Product Change Notification / JAON-18KOPA638

CCB 5014.005 Initial Notice: Qualification of a new die size (1.932x1.860mm) for Die #1 of selected Microsemi LE9653AQC, LE9653AQCT, LE9621AQC, LE9643AQC, LE9621AQCT, and LE9643AQCT catalog part numbers (CPN) available in 36L VQFN (4x6x1mm) package assembled at MTAI assembly site.

CCB 5014.005
Pre and Post Change Summary
PCN#: JAON-18KOPA638

Pre and post change comparison

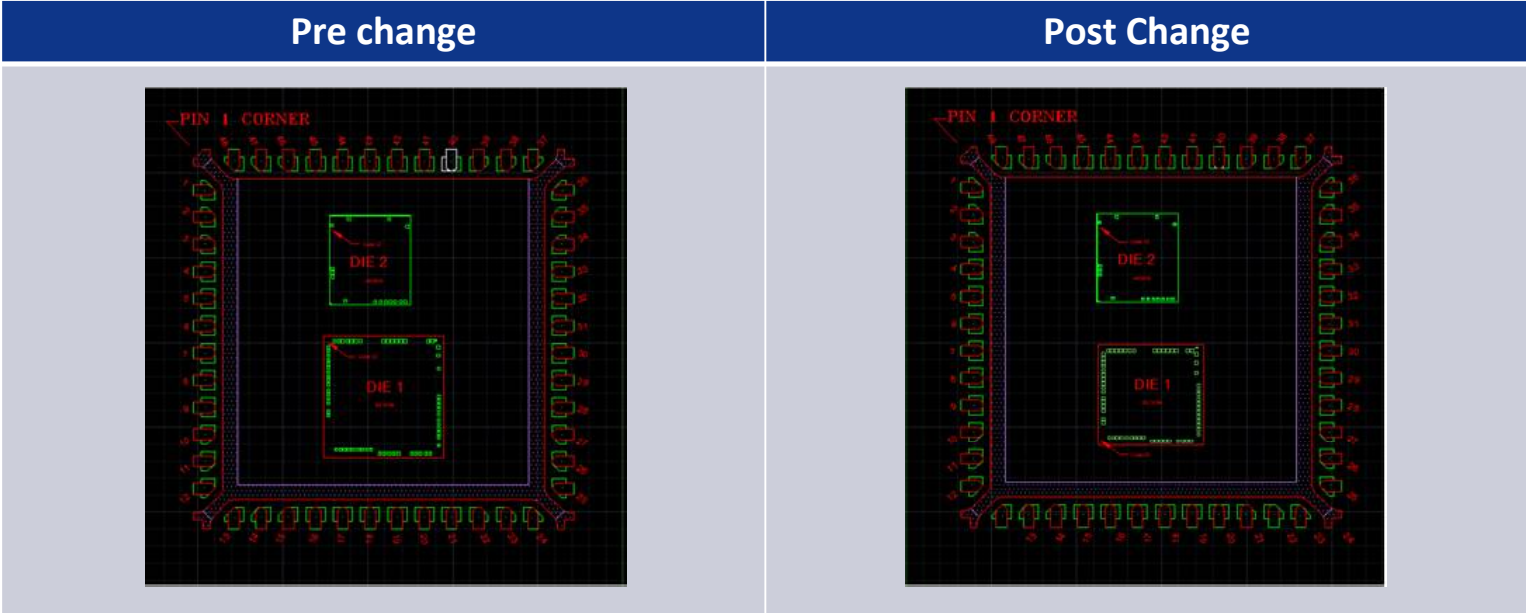
Description of Change:Qualification of a new die size (1.932x1.860mm) for Die #1 of selected Microsemi LE9653AQC, LE9653AQCT, LE9621AQC, LE9643AQC, LE9621AQCT, and LE9643AQCT catalog part numbers (CPN) available in 36L VQFN (4x6x1mm) package assembled at MTAI assembly site.

Pre Change		Post Change	
Fabrication Location	Die # 1	Global Foundries, Singapore - Fab 7 (GF07)		Global Foundries, Singapore - Fab 7 (GF07)	
	Die # 2	Global Foundries, Singapore - Fab 2 (GF02)	Microchip Technology Colorado – Fab 5 (MCSO)	Global Foundries, Singapore - Fab 2 (GF02)	Microchip Technology Colorado – Fab 5 (MCSO)
Die Size	Die # 1	2.204 x 2.258 mm		1.932x1.860mm	
		Please see attached pre and post change comparison for Die # 1 Location			
	Die # 2	1.57 x 1.72 mm		1.57 x 1.72 mm	
Assembly Site		Microchip Technology Thailand (HQ) (MTAI)		Microchip Technology Thailand (HQ) (MTAI)	
Wire Material		CuPdAu		CuPdAu	
Die Attach Material		3280		3280	
Molding Compound Material		G700LTD		G700LTD	
Lead Frame Material		A194		A194
